Health Consultation

HOPEWELL PRECISION AREA
GROUNDWATER CONTAMINATION SITE
TOWN OF EAST FISHKILL,
DUTCHESS COUNTY, NEW YORK

JULY 3, 2012

Hopewell Precision Area Groundwater Contamination Site
Health Consultation
Summary of Response to Public Comments

FIGURE 1. SITE LOCATION AND GROUNDWATER PLUME MAP

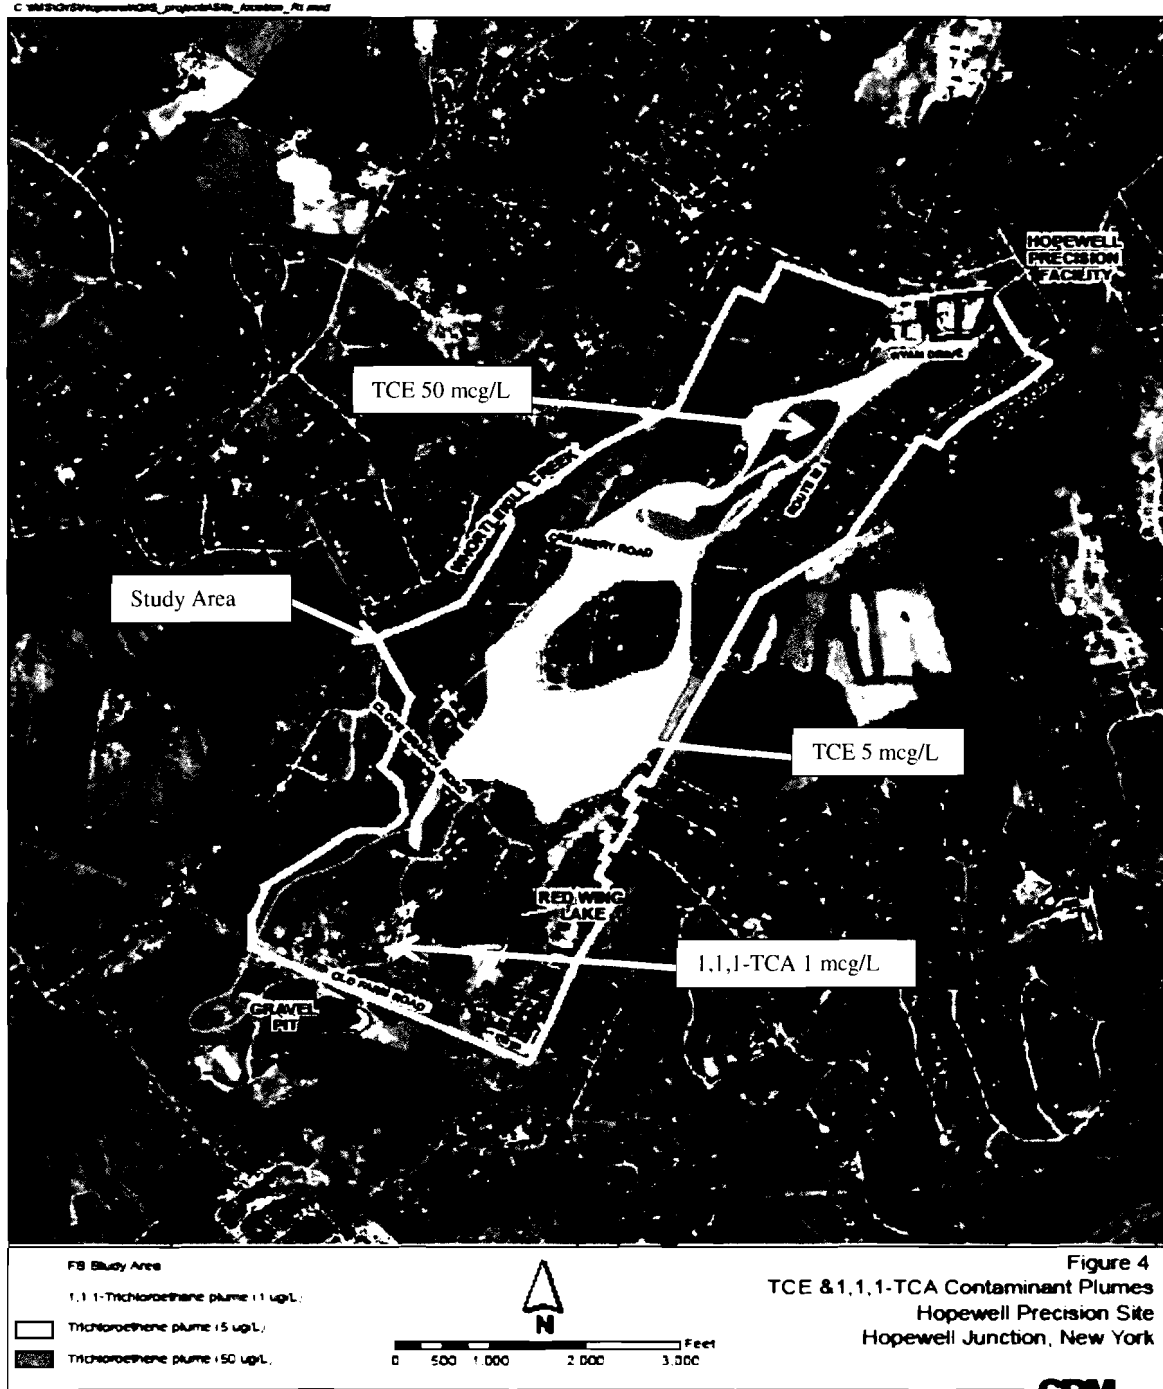
COMMENT 17: Figure 1 – Difficult to decipher. Need the plume boundaries defined more clearly. What does the white area in the middle represent (5 – 50 mcg/L)? What does the white perimeter line represent <5 mcg/L?

RESPONSE 17: The smaller inner plume represents 50 mcg/L of TCE, the larger plume represents 5 mcg/L of TCE. Captions have been added to aid in deciphering Figure 4. Additional figures are available in the 2008 Remedial Investigation Report available at the Town of East Fishkill Community Library document repository and on the EPA's website. <http://www.epa.gov/region2/superfund/npl/hopewell/relateddocs.htm>
